Location:
160 College Street

Request:
Conditional Use and Site Plan request for an addition to Western Reserve Academy's Ellsworth Hall

Case Manager:
Nick Sugar, City Planner

Hudson Planning Commission	CONDITIONAL USE/SITE PLAN REVIEW – ELLSWORTH HALL
Case No. 2023-789	October 9, 2023

Figure 1

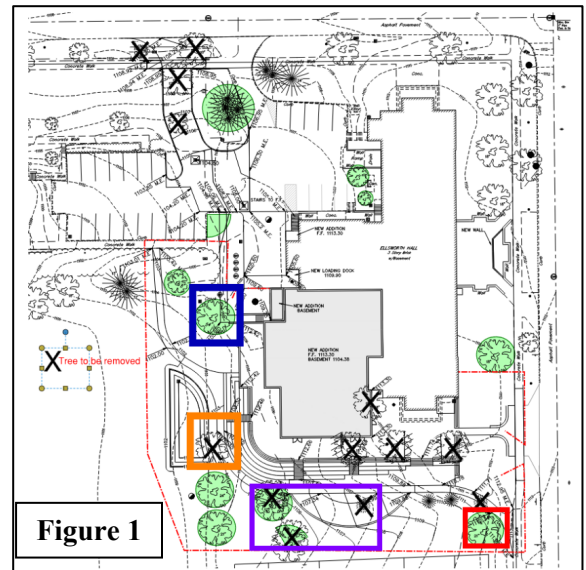
- Tree and Vegetation Protection 1207.02** Community Development staff reviewed the proposed tree clearing and landscaping plan with the City Arborist onsite. The City Arborist provided the following comments:

- A significant white oak tree was observed in the area highlighted in blue in Figure 1. The plans depict protective fencing around the tree; however, a concrete sidewalk is depicted directly adjacent. Document how this tree will be protected through construction.

- A mature red oak would be removed to construct the detention pond. This area is highlighted in orange in Figure 1. Question if the pond area could be adjusted to preserve this tree.

- A stand of Sweetgum trees are proposed to be removed to construct the outdoor seating area. These trees are highlighted in purple in Figure 1. These trees do not appear significant and could be considered a nuisance tree.

- The plan depicts grading directly through the Locust tree highlighted in red in Figure 1. Revise the grading plan to be outside of the critical root zone if the intent is to preserve this tree.

- Question if one access drive could be maintained along East Prospect Street to preserve the mature Honey Locust, Sawtooth Oaks, and White Linden in this area.

1. Revise the East Prospect Street access design to a single access and reduced curb width.
2. Revise the height of the loading dock wall to have a maximum height of eight feet to be compliant with Section 1206.03(b)(5)(B).
3. Revise the proposed landscaping plan to address the comments of the City Arborist, including:
 1. Document how the mature White Oak located at the rear of the building would be protected through construction subject to approval by the city arborist.
 2. Revise the pond layout to preserve the adjacent, mature Red Oak.

3. Revise the grading plan to relocate grading outside of the existing Locust tree along College Street, near the location of the existing driveway.
4. Preserve additional trees along East Prospect Street per staff's previous comments #1 above.
5. Submit a landscape bond in an amount equal to 110 percent of the cost of the installations.
4. Reduce lighting levels in the areas along the proposed outdoor seating area depicted in Figure 2 of the staff report.
5. The comments of Assistant City Engineer David Rapp shall be addressed per the September 29, 2023 correspondence.

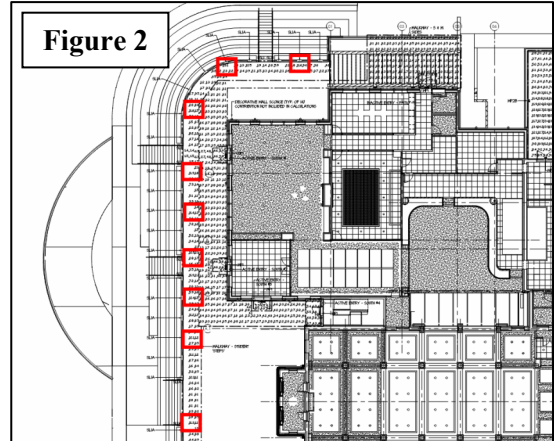
Staff notes compliance with the required lighting standards; however, there are a few specific locations along the southern seating area with high lighting levels in excess of 10 footcandles (see Figure 2). Though the lighting levels are calculated on an average, staff recommends these levels be reduced as they are pedestrian areas that should have lower lighting levels.
